UCS M5刀片DIMM填充标签与文档不匹配

本文档介绍旧UCS M5刀片DIMM填充贴纸不反映当前在线文档的问题。

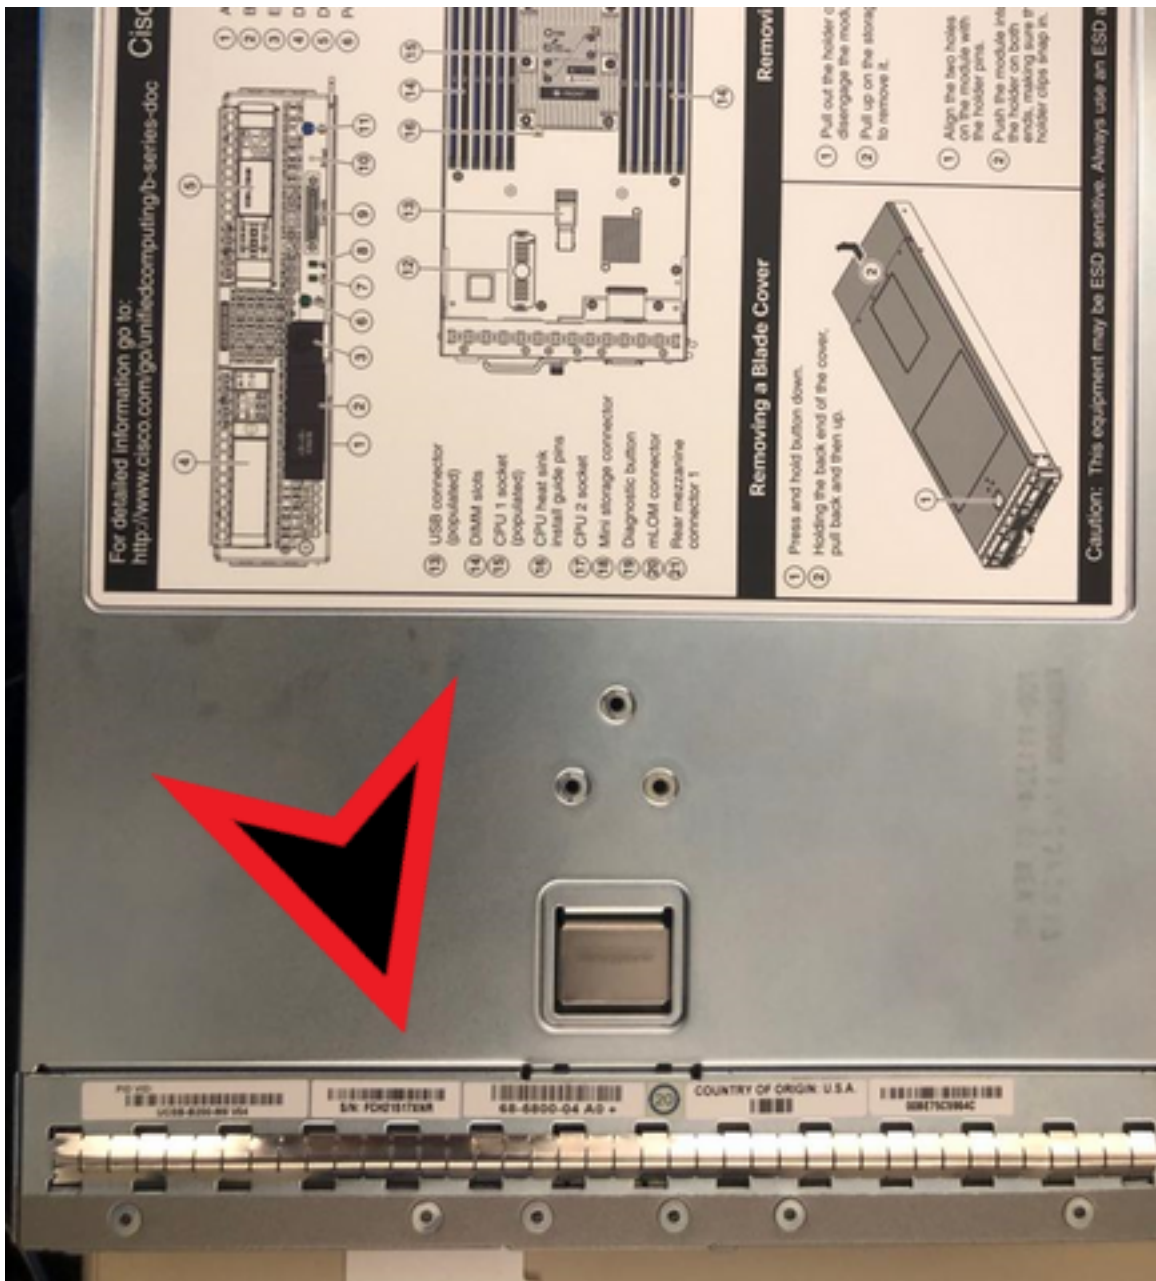
FCS后测试发现，DIMM填充的最佳配置与最初发布的规格不同。原始种群规则确实运行正常，但通过使用文档中发布的最新指南可以获得最佳性能。刀片盖下的贴纸已根据ECO EA553015（于2018年5月实施）进行更改，技术文档已于2017年12月更新。大约15K-20K刀片随原始DIMM填充贴纸一起发货。

- UCS B200 M5
- UCS B480 M5
- 上盖(800-46239-01)有B0版（固定贴纸有C0版）

- 顶部组件编号(68-5800-04)具有A0修订版（固定版本为B0）

以下是B200-M5的旧贴纸供参考：

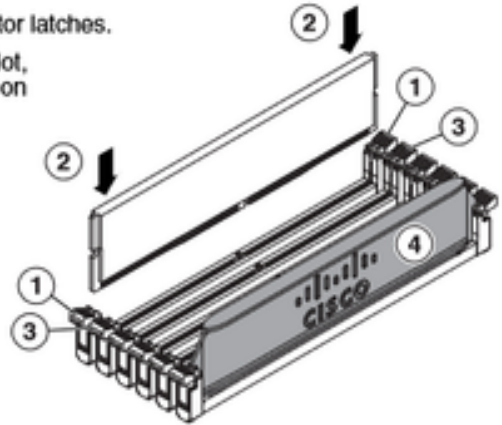
UCS M5刀片盖下的DIMM填充标签与在线UCS文档中的信息不匹配。

两种配置均有效且受支持。旧标签不应阻止发现或任何其他问题，但它不是性能的最佳配置。应该注意的是，性能差异很小（大约1%）。

原始DIMM填充标签并不不正确，但应将客户引导至在线文档，以获取最新且最佳配置。
